## SERVICE BULLETIN

SUBJECT TS-930S ALC LEVEL DRIFT 28 MHZ CW

DATE 8-25-83

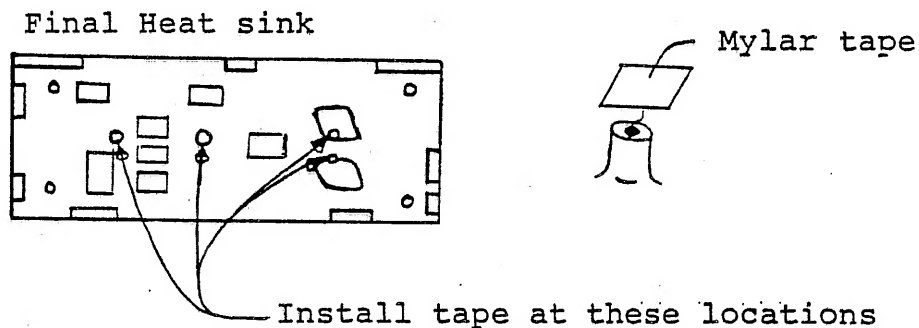
Some users have reported that the ALC meter indication occasionally jumps during long key down periods on the 28 Mhz portion of the bands. The symptom may be caused by the ground foil of the Final Unit (X56-1430-00) coming in contact with one or more of the projections on the final heat sink, due to expansion when the temperature rises.

Apply mylar insulating tape to the projections on the heat sink, to prevent reoccurrence of this symptom. See figures below.
